COMMUNITY DEVELOPMENT DEPARTMENT REPORT

SUBJECT: H-2024-0069
Springday Subdivision – AZ, PP

LOCATION: North side of W. Ustick Rd., 1/4 mile west of N. Black Cat Rd., in the SE 1/4 of Section 33, T.4N., R.1W. (Parcel #S0433438957 & #S0433438850)

VII. Exhibits

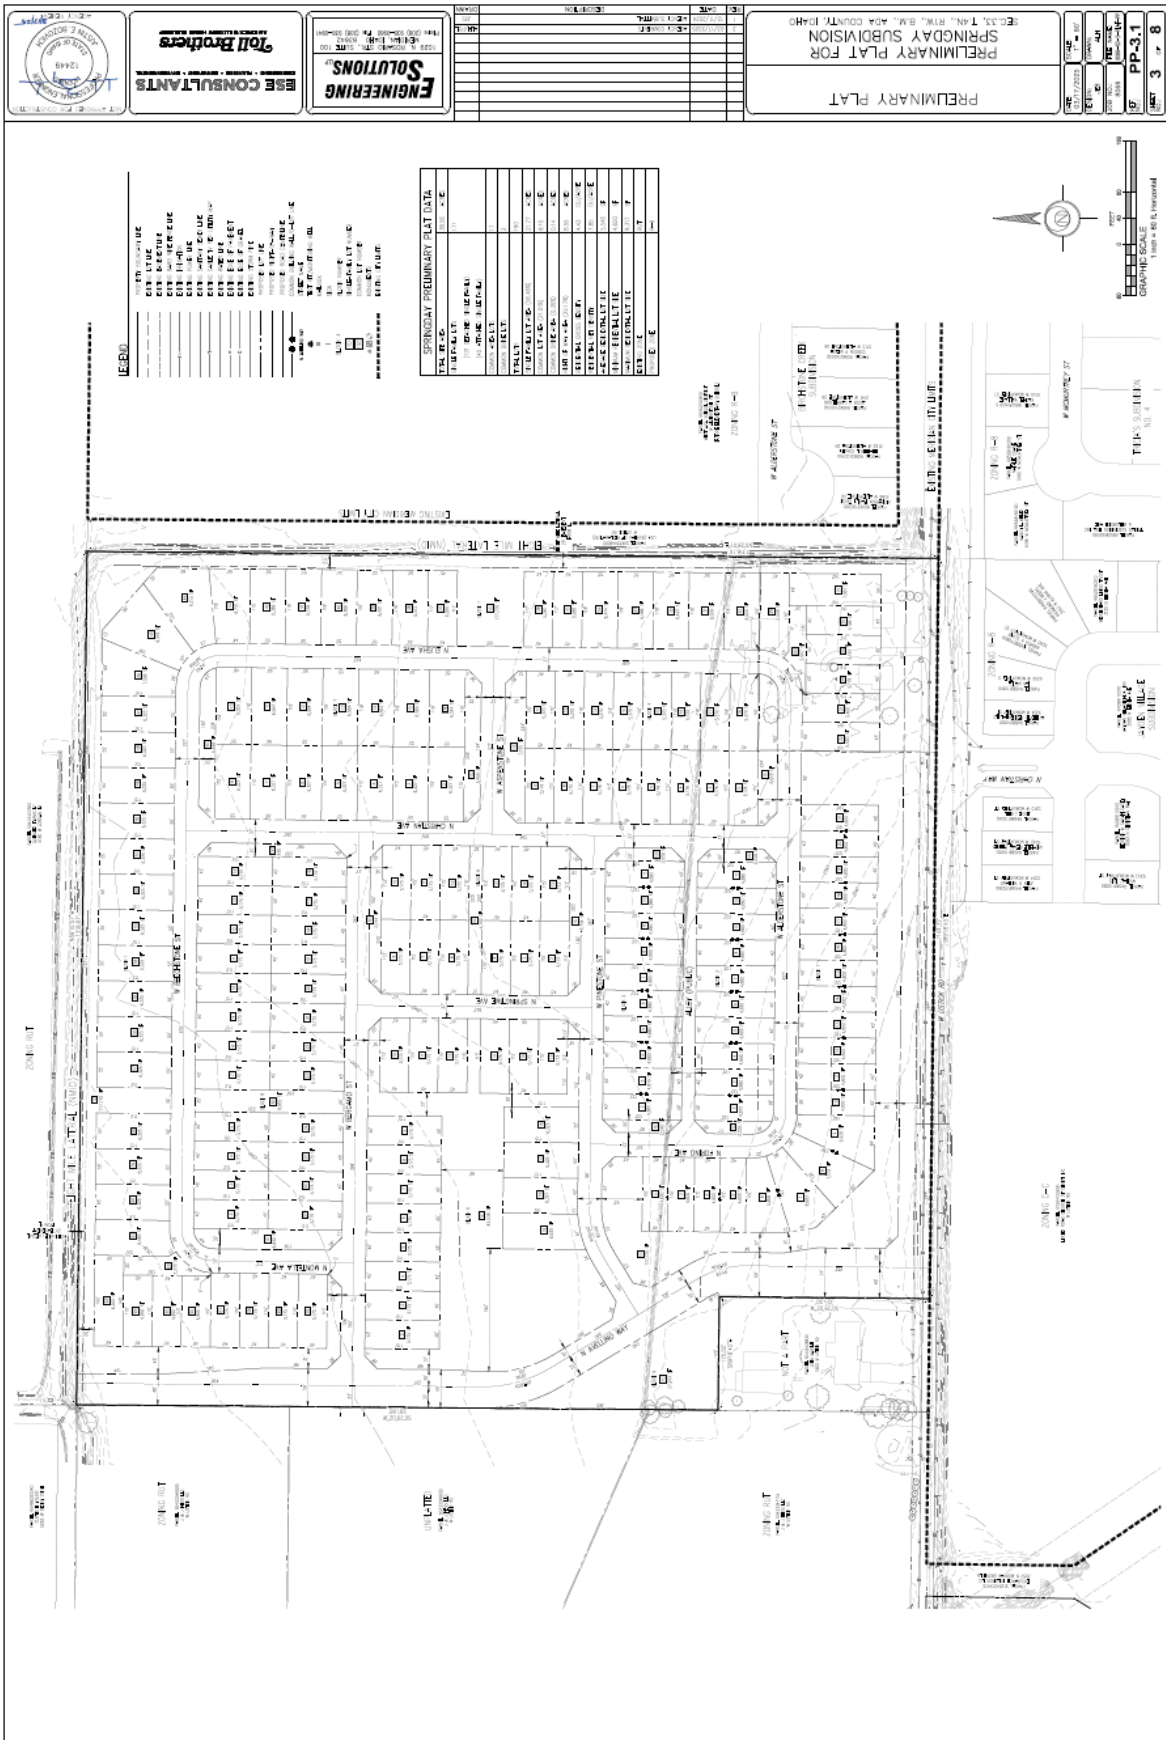
Two (2) common driveways are proposed; see exhibit in Section VII.F below. **All common driveways are required to comply with the standards in UDC 11-6C-3D, which require driveways to be a minimum 20' in width and no more than three (3) dwelling units may be located on one (1) side of the driveway. The plat depicts four (4) dwelling units on one side of each of the driveways and the paved surface of the driveways is below 20 feet. If solid fencing is proposed adjacent to common driveways, a minimum 5-foot wide landscape buffer planted with shrubs, lawn or other vegetative groundcover should be provided between the driveway and fence. The common driveway exhibits, preliminary plat and landscape plan should be revised to comply with these standards with submittal of the final plat application.**

2. The final plat shall include the following revisions:
 - i. Make revisions to the plat to comply with the common driveway standards listed in UDC 11-6C-3D.
 - ii. Depict a temporary turnaround at the north end of N. Avellino Way as required by ACHD.
 - iii. Depict a minimum 35-foot-wide street buffer along the entire frontage of the property along Ustick Rd. in accord with UDC Table 11-2A-6 for entryway corridors, measured from the ultimate sidewalk location as anticipated by ACHD after right-of-way is dedicated for the expansion of Ustick Rd. Depict the ultimate sidewalk location on the plan as anticipated by ACHD.

6. Submit a revised common driveway exhibit that demonstrates compliance with the standards listed in UDC 11-6C-3D.
7. All existing structures shall be removed from the site prior to the City Engineer's signature on the final plat.

G. Landscape Plan (dated: 11/22/2024)

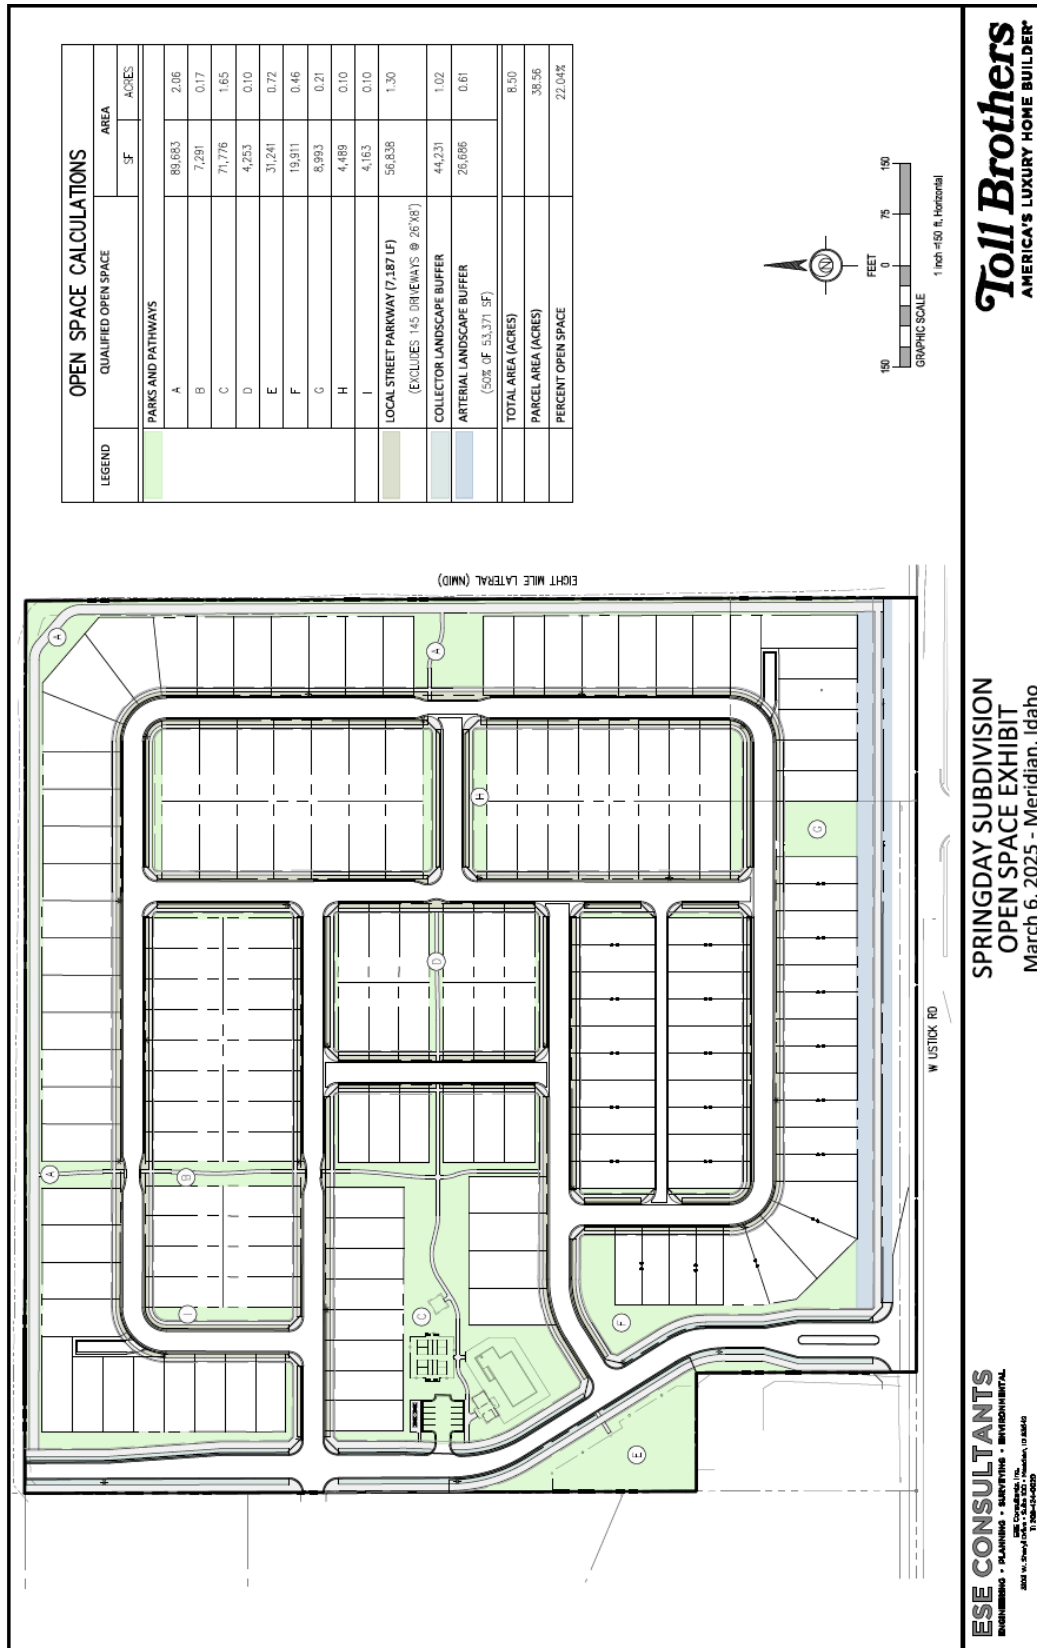
3. The landscape plan submitted with the final plat application shall include the following revisions:
 - i. Depict a gate or bollards to restrict access to the emergency access driveway via W. Ustick Rd. as determined by the Fire Dept.

- ii. Depict a temporary turnaround at the north end of N. Avellino Way as required by ACHD.
 - iii. All pathways shall be located outside of irrigation district easements unless permission is specifically obtained from the governing Irrigation District or Bureau of Reclamation as applicable.

- iv. Depict a minimum 35-foot-wide street buffer along the entire frontage of the property along Ustick Rd. in accord with the standards listed in UDC 11-3B-7C; additional landscape design features are required for entryway corridors. The buffer shall be measured from the ultimate sidewalk location as anticipated by ACHD after right-of-way is dedicated for the expansion of Ustick Rd. Depict the ultimate sidewalk location on the plan as anticipated by ACHD.

- v. Depict landscaping in all street buffers in accord with the standards listed in UDC 11-3B-7C, which require landscape areas to be designed and planted with a variety of trees, shrubs, lawn or other vegetative groundcover that elicit design principles including rhythm, repetition, balance and focal elements.

- vi. Minimum 5-foot-wide landscape strips are required along each side of all pathways, landscaped per the standards in UDC 11-3B-12C, which require a mix of trees, shrubs, lawn and/or other vegetative groundcover. The depth of lots along the north and east boundaries of the site may need to be adjusted in order to provide a minimum width of 5 feet outside the Eightmile Lateral easement for the required landscaping. Designs are encouraged in which the width of the landscape strip varies to provide additional width to plant trees farther from the pathway, preventing root damage. The minimum width of the landscape strip shall be two (2) feet to allow for maintenance of the pathway.

- vii. Include mitigation calculations in accord with the standards listed in UDC 11-3B-10C.5. The Applicant should contact the City Arborist (Kyle Yorita 208-409-1601) to schedule an inspection prior to removal of any trees from the site.

- viii. Depict landscaping in common open space areas per the standards listed in UDC 11-3G-5B.3, which require a minimum of one (1) deciduous shade tree for every 5,000 sq. ft. of area and include a variety of trees, shrubs, lawn or other vegetative groundcover. Include calculations that demonstrate compliance with this standard.
